Addendum 01

Modesto Junior College, East Campus
Football Field Press Box & Elevator
435 College Ave., Modesto, CA 95350

Date : October 16, 2026
TETER Project No.: 21-12111

Client Project No.: 26-1957
DSA File No.: 50-C1
DSA Appl. No.: 02-123619

OVERALL ELECTRICAL SITE PLAN

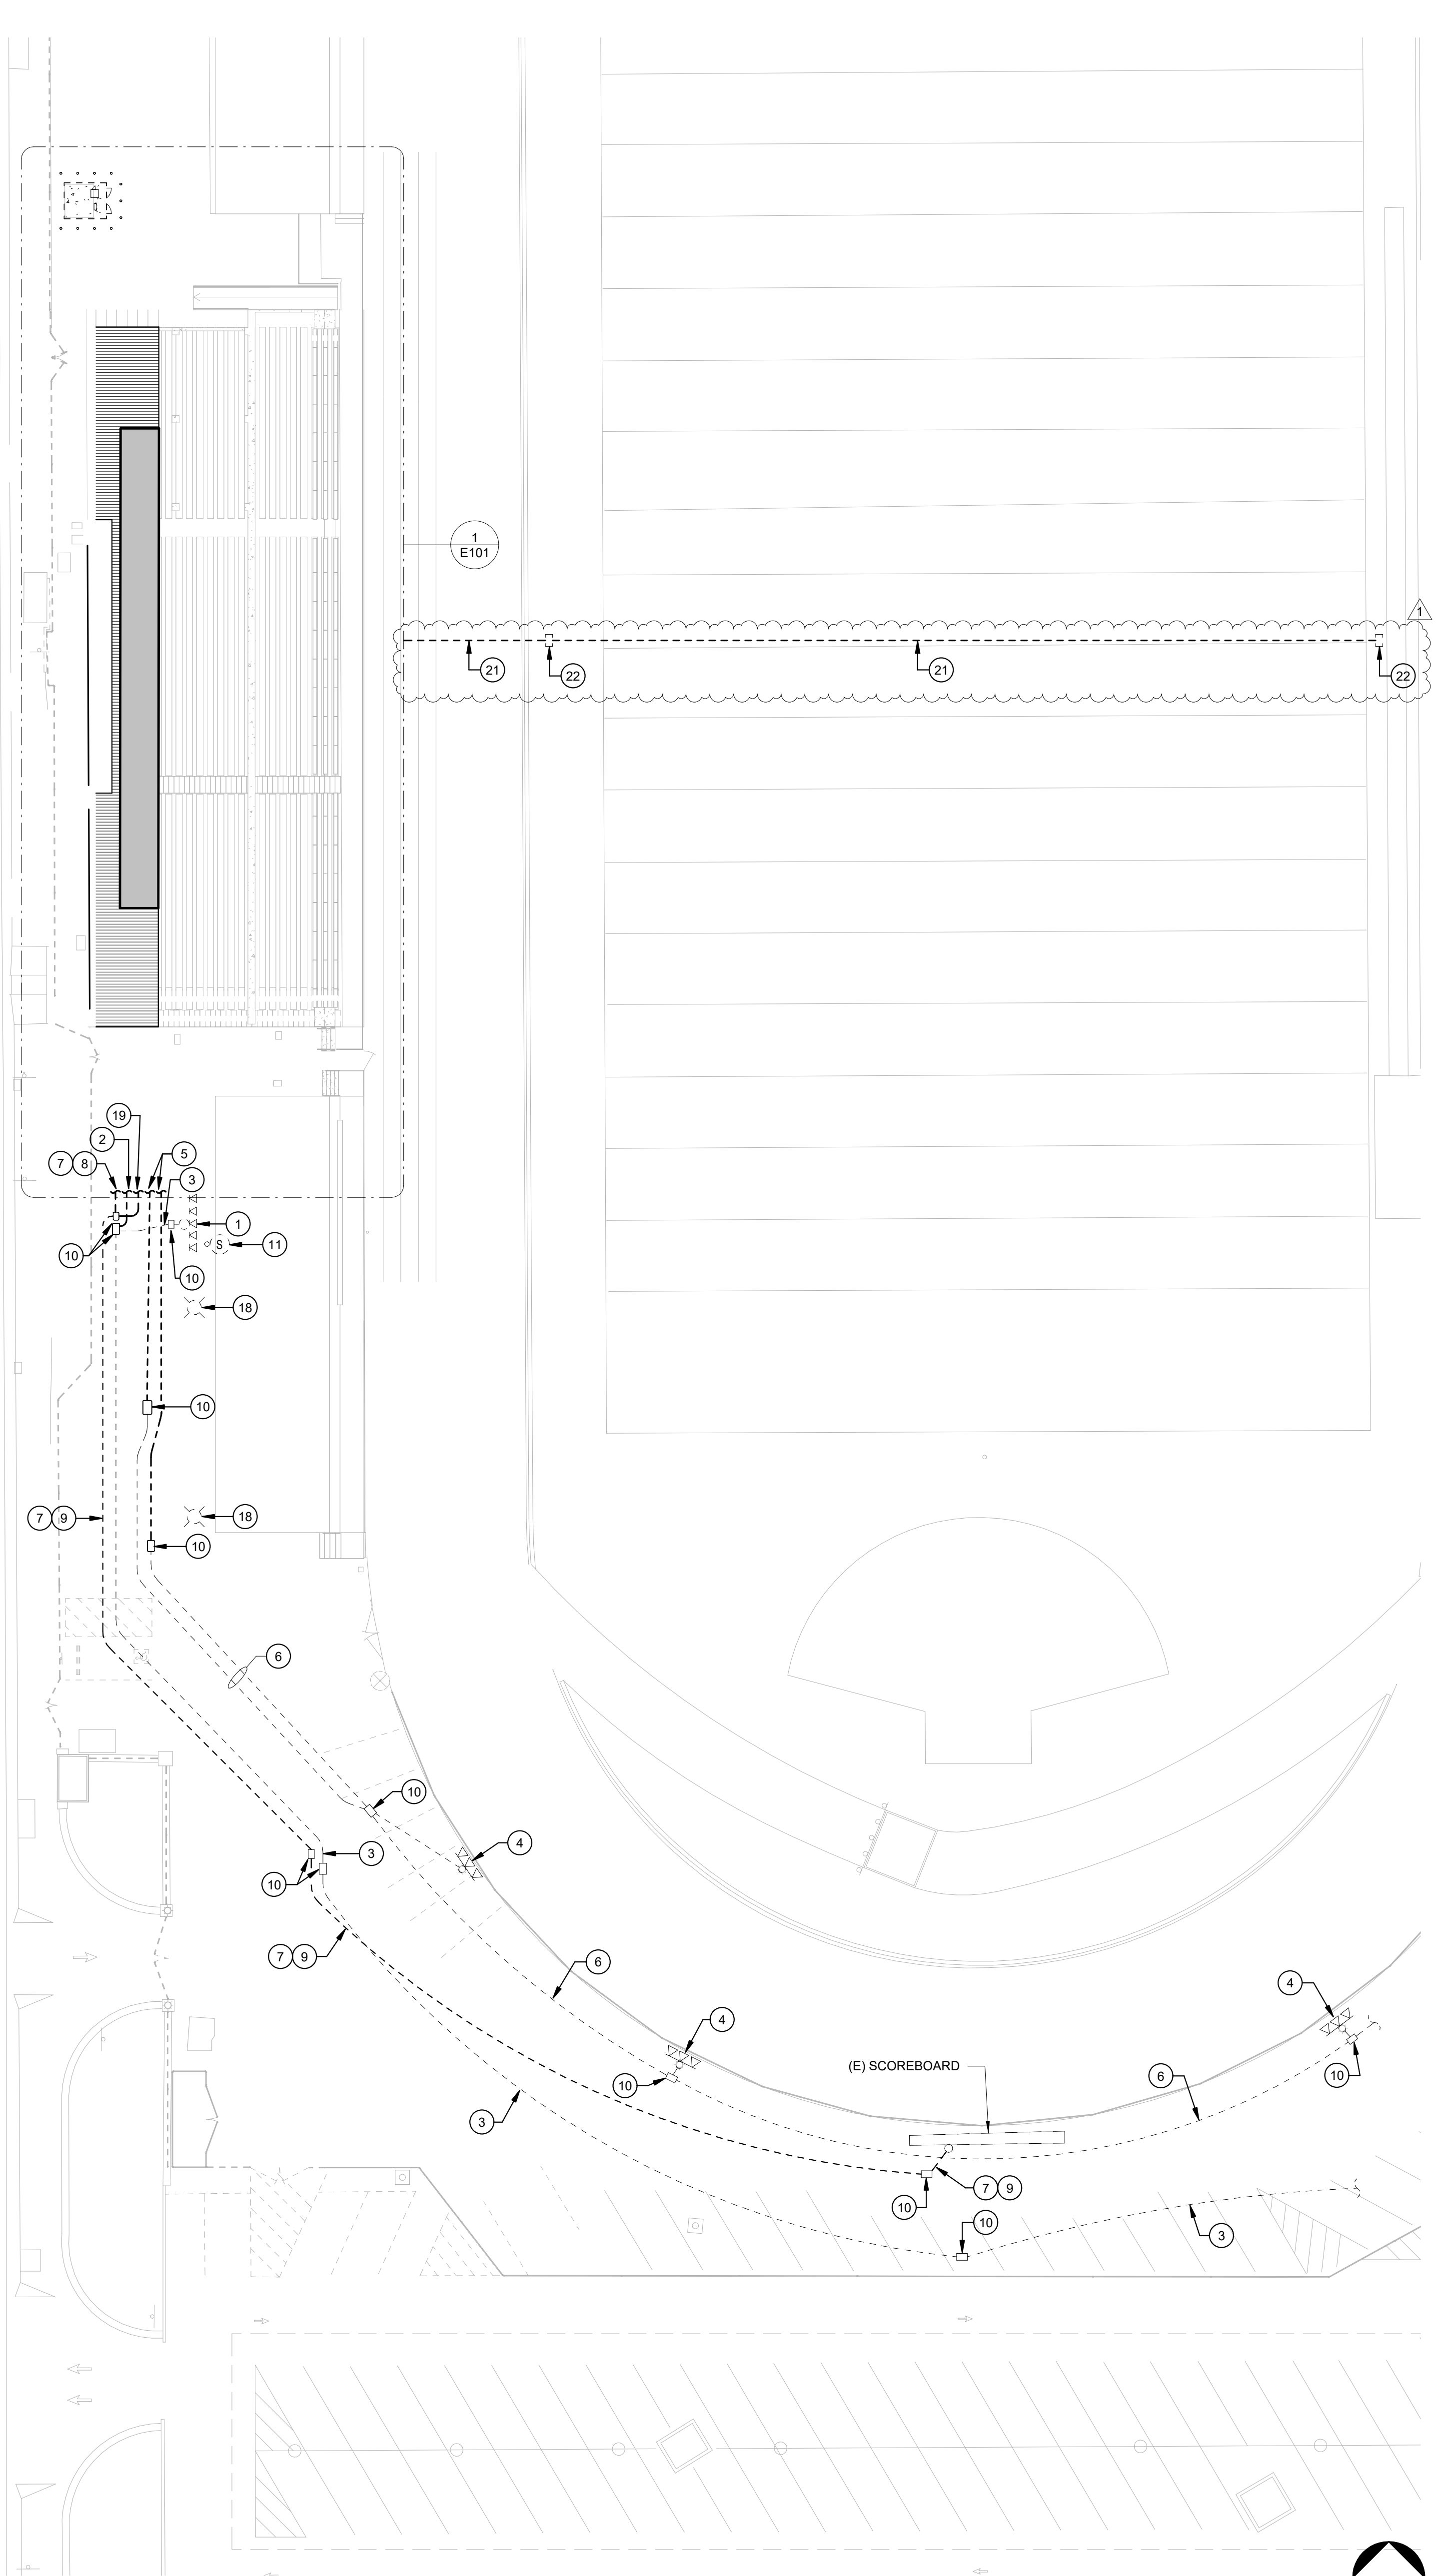
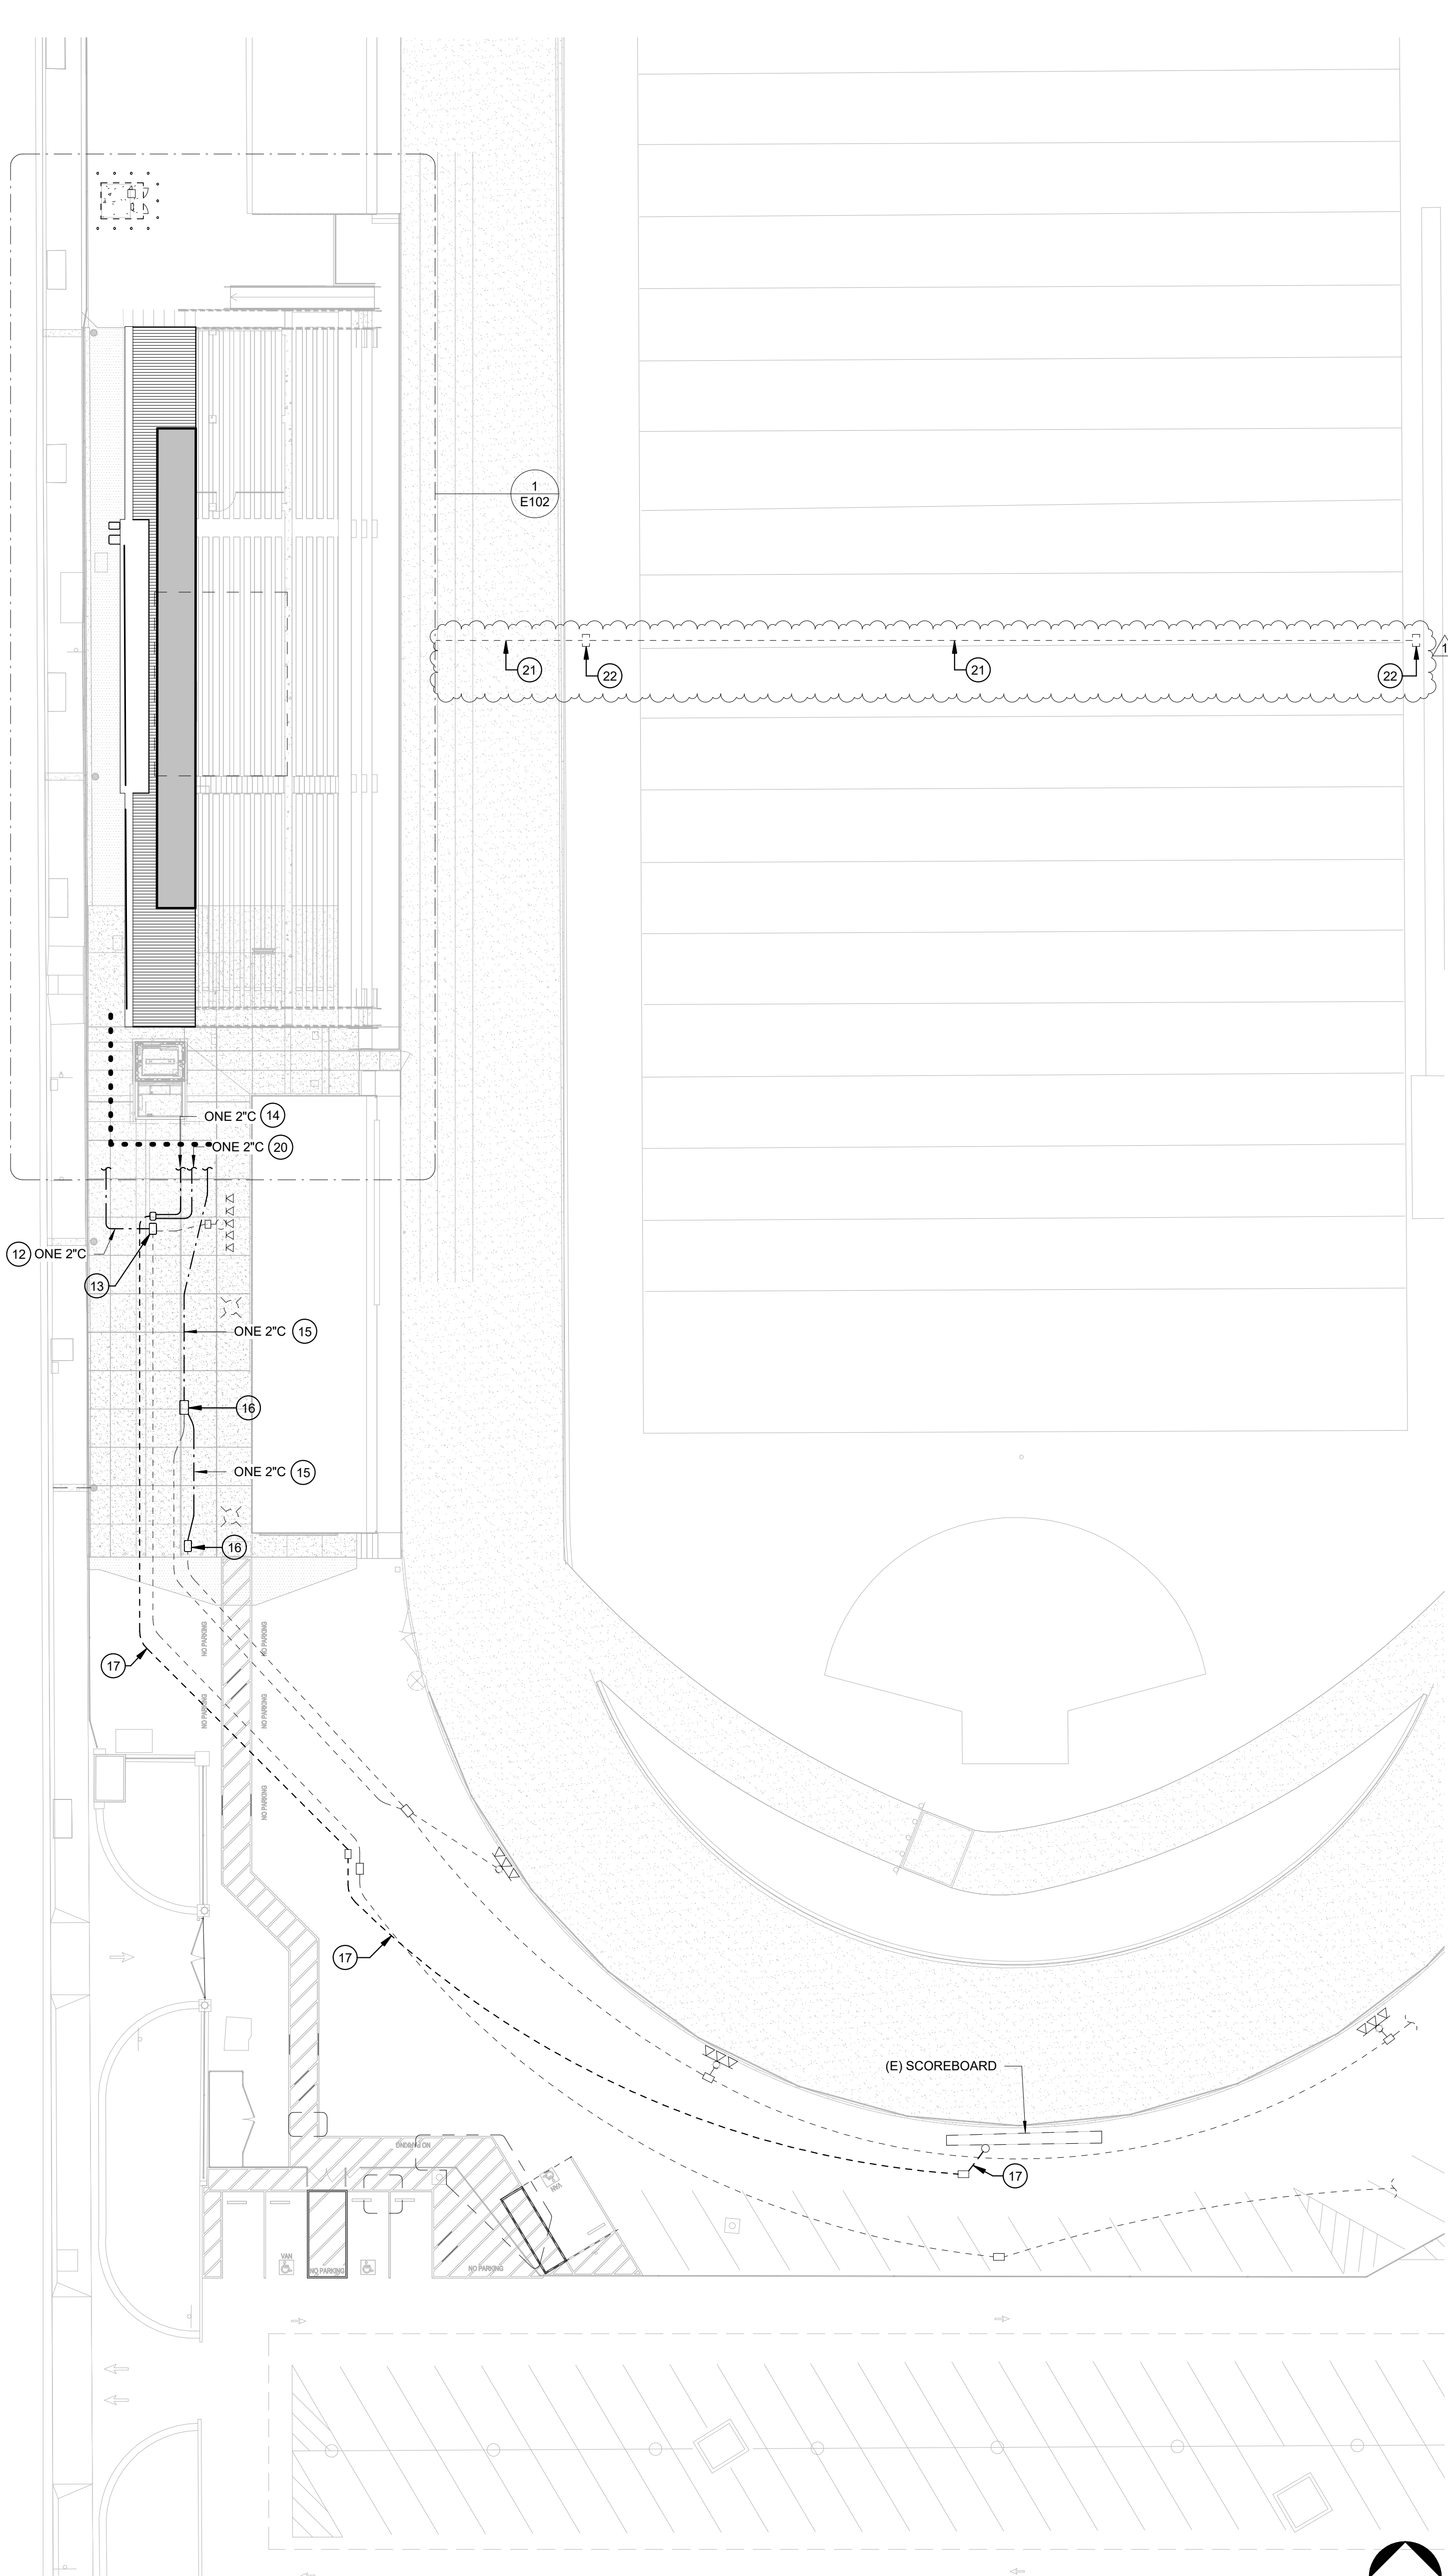
1 - 020: PROJECT DRAWINGS, SHEET E100 – “OVERALL ELECTRICAL SITE PLAN”, revise as follows:

A. Delete Sheet E100 in its entirety and replace with the attached drawing E100. (See attachment **AD01-E01, E100**)
